HEARINGS OFFICER HEARING - LAND USE: HOMAN OUTDOOR MOTOCROSS FACILITY

FILE NUMBERS: 247-22-000812-CU / 247-22-000813-SP

STAFF REPORT

REQUEST: The applicant requests conditional use and site plan approval for a recreation-oriented facility ("ROF") requiring large acreage. Specifically, the ROF will include four (4) outdoor motocross course/tracks.

Figure 4 – Cline Falls Airpark Noise Impact Boundary (Pink) & Subject Property (Red)

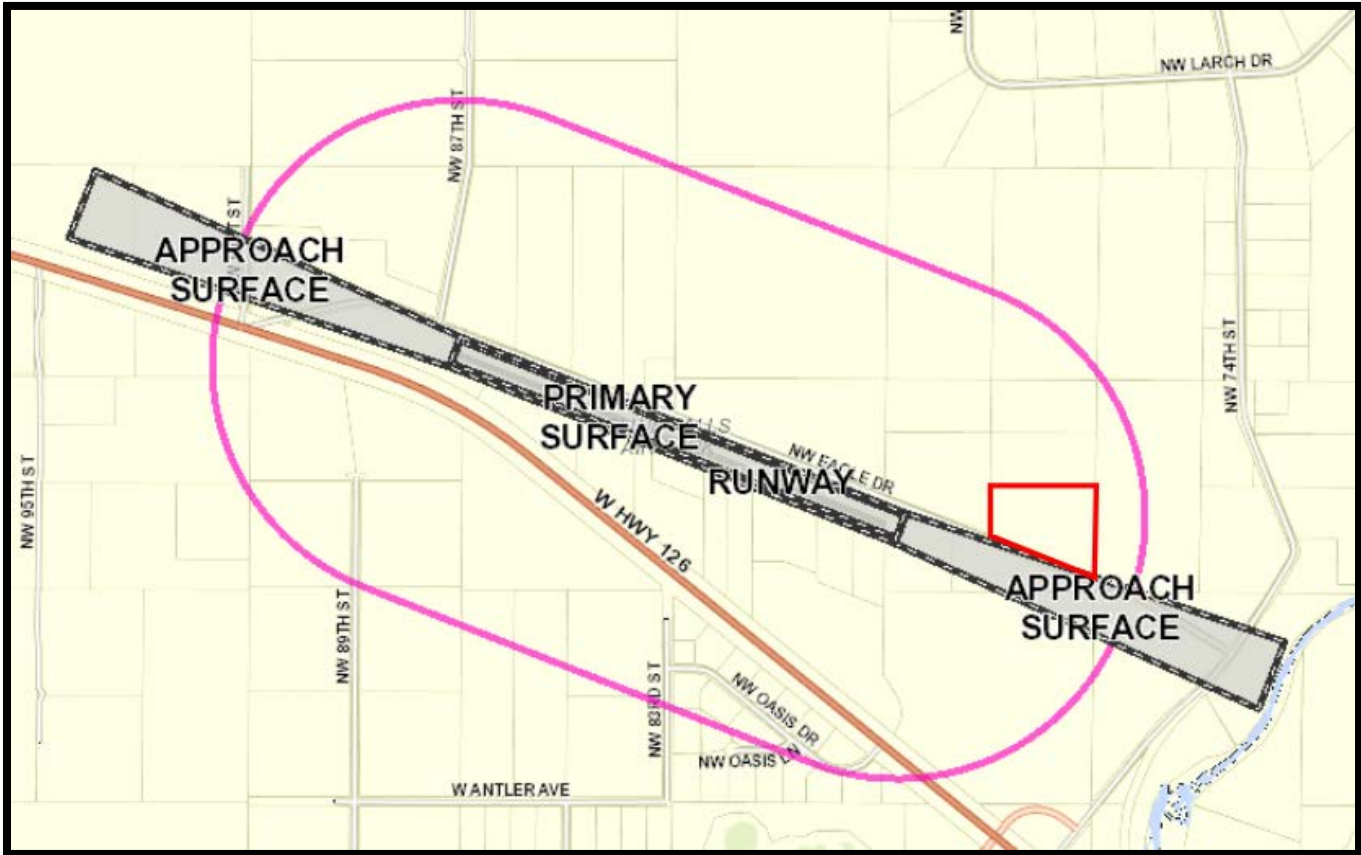
FINDING: The subject property is not located under any of the imaginary surfaces for the Cline Falls Airpark. However, the subject property is located within the Noise impact Boundary for the Cline Falls Airpark (see *Figure 4* below). Therefore, the provisions of this chapter apply.
